A. **Public Meeting** for Case 26-01: Comprehensive Sign Plan, Raising Cane's at 17601 Halsted Street

MEMORANDUM

Topic: Case 26-01: Comprehensive Sign Plan/Signage Appearance Review for Raising Cane's Restaurant, 17601 Halsted Street

Figure 1: Proposed Monument Sign

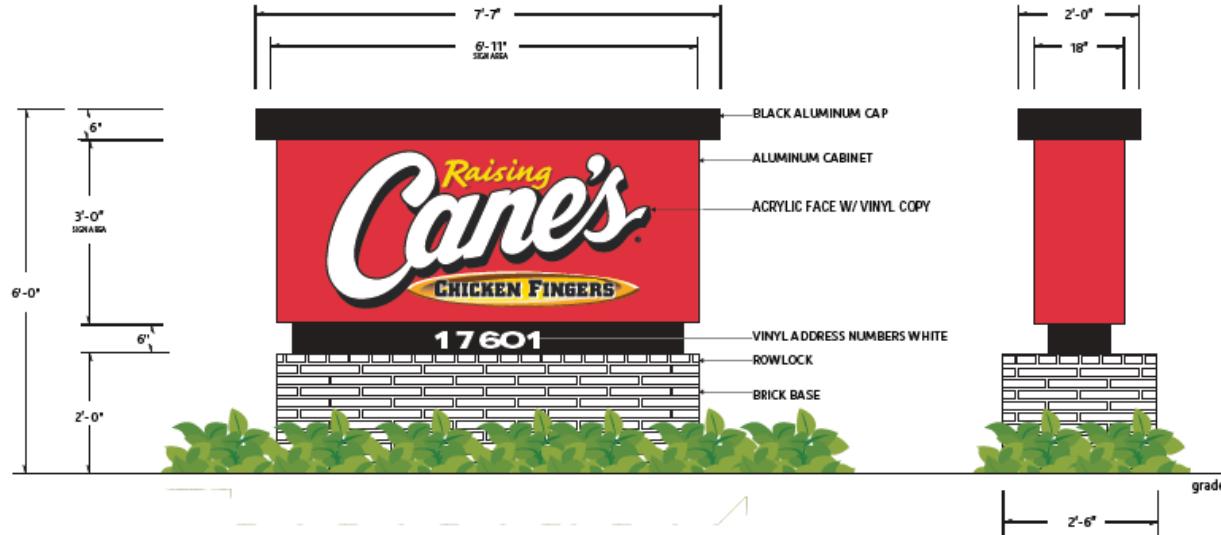
The applicant has proposed a new monument sign on the western frontage of the property along Halsted Street. The new sign will be constructed on top of the base of the existing monument sign on the site, which was used for Freddy's Restaurant. This site is permitted to have one (1) monument sign per Section 44-10-06 (Commercial Signs) of the Zoning Ordinance. The double-sided sign will have a total of 46 s.f. of sign copy (23 s.f. on each side, perpendicular to Halsted Street). The sign will be a total of 6' in height, including the existing brick monument sign base. The new sign will be constructed of an

aluminum sign cabinet with acrylic and vinyl sign faces. **The proposed monument sign meets all zoning requirements for this type of sign. An Appearance Review is required for any new monument sign construction under the newly-adopted 2025 sign code.**

Figure 2: Examples of Proposed Wall Signage

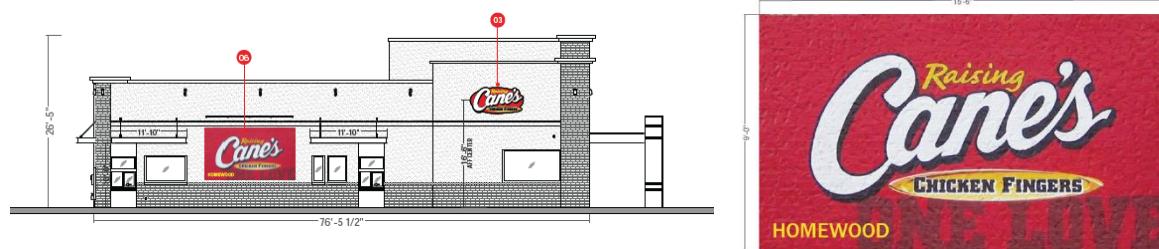
The applicant has proposed one (1) aluminum cabinet wall sign on each of the four (4) facades of the building. The applicant has also proposed one (1) additional aluminum panel wall sign on the south (interior side) elevation of the building. The Zoning Ordinance allows one (1) wall sign per frontage for property in the B-4 zoning district where the subject property is located. Per Section 44-10-06 (Commercial Signs) of the Zoning Ordinance, signs are permitted on the west (front) and north (exterior side) elevations of the building. **The applicant has requested a modification through the Comprehensive Sign Plan review to allow for two (4) additional wall signs – see *Modification Request* below.**

- No more than 130 s.f. of total wall signage
- No more than 6 wall signs on the entire building
- No more than 2 wall signs per elevation
- Internal illumination except where site conditions or safety concerns do not permit it
- Wall signs may only be constructed as cabinets or channel letters, and may only be mounted to walls and canopies

Figure 4: Proposed Canopy Sign

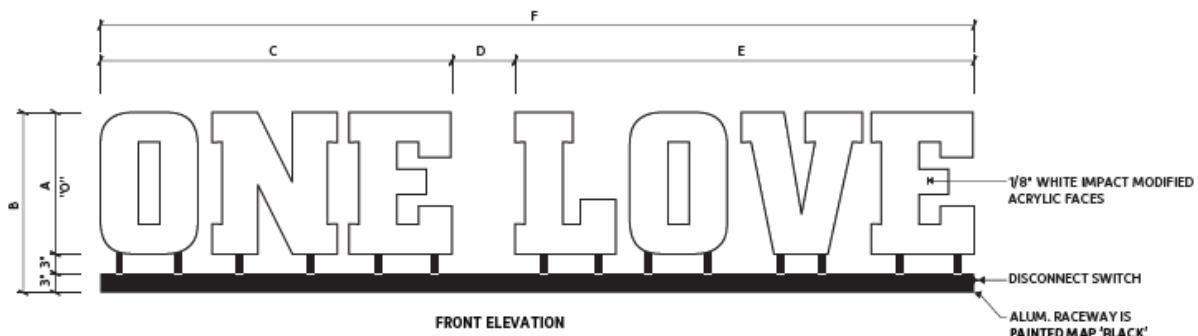
The applicant has proposed one (1) canopy sign on the west (front) side of the building. This sign will be mounted to the top of a new canopy structure located over an outdoor dining area. This sign will be comprised of individual aluminum cabinet letters with translucent acrylic faces. The canopy sign is proposed to be 17.5 square feet in area. **The proposed canopy sign meets all zoning requirements for this type of sign.**

Figure 5: Proposed Menu Board Signs

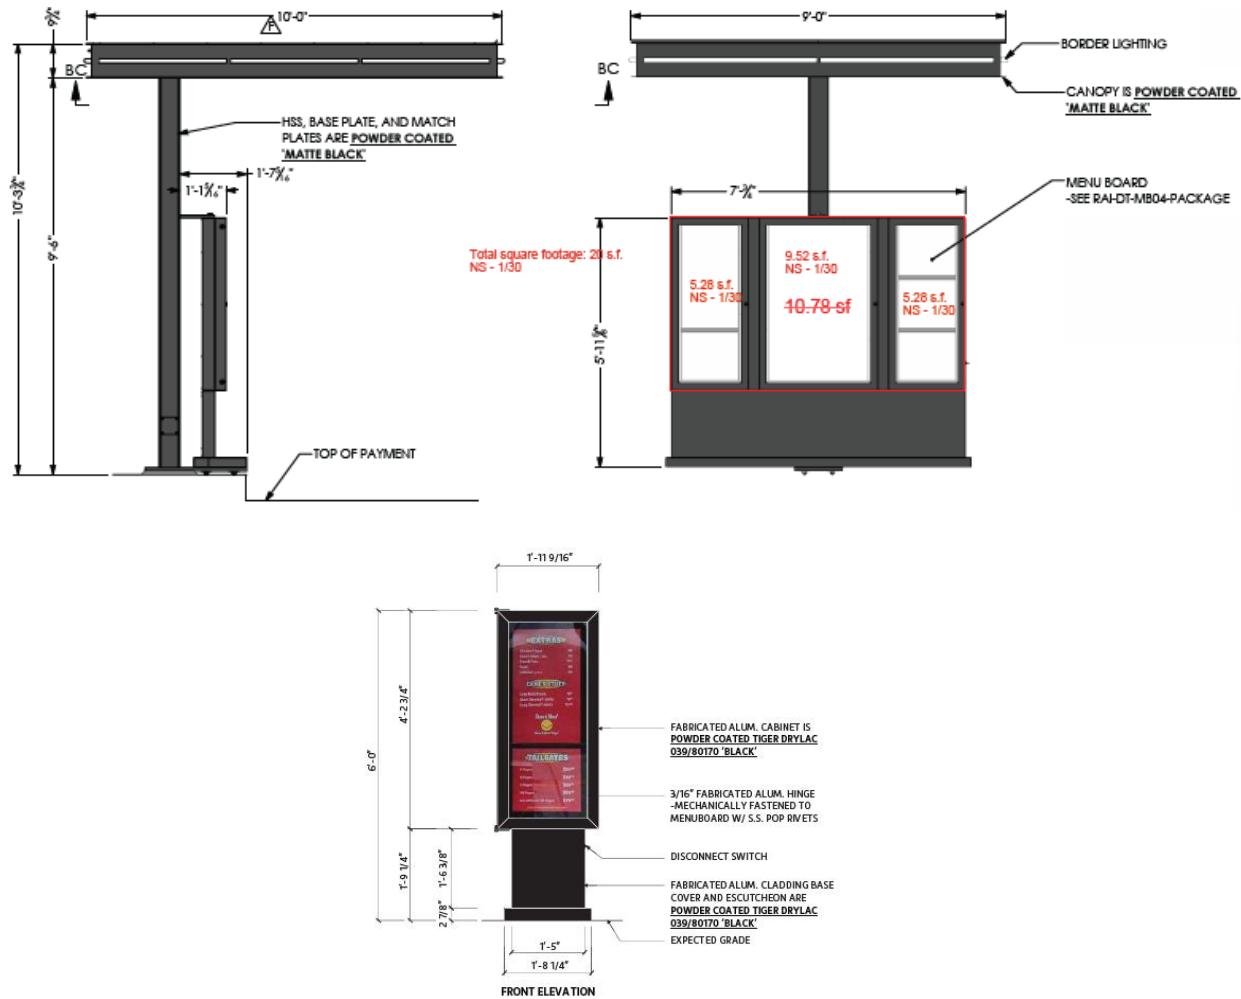
The applicant has requested three (3) menu board signs. This package of menu board signs includes one (1) "pre-sale" sign located near the entrance to the drive-through facility and two menu boards to service the two drive-through aisles. The pre-sale sign is proposed to be 12 square feet in sign area, encased in a black aluminum frame which matches other finishes across the main restaurant building. The pre-sale sign will be mounted 2' above grade on a support structure.

The two menu board signs are proposed to be 29.5 square feet in area, encased in a black aluminum frame with a matte finish which matches other finishes across the main restaurant building. These signs are proposed to be mounted to a large attached canopy, and mounted 2' above grade on a support structure. The total sign area will be 40 square feet between the two signs.

The Zoning Ordinance permits two (2) menu boards per location. **The applicant has requested a modification through the Comprehensive Sign Plan review to allow for one (1) additional menu board sign.**

- No more than three total menu board signs with two speaker poles
- No additional size permitted for the pre-sale menu board
- No additional size allowed for menu board signs
- Two main menu boards should include a matching attached canopy not to exceed 10' 4" in height
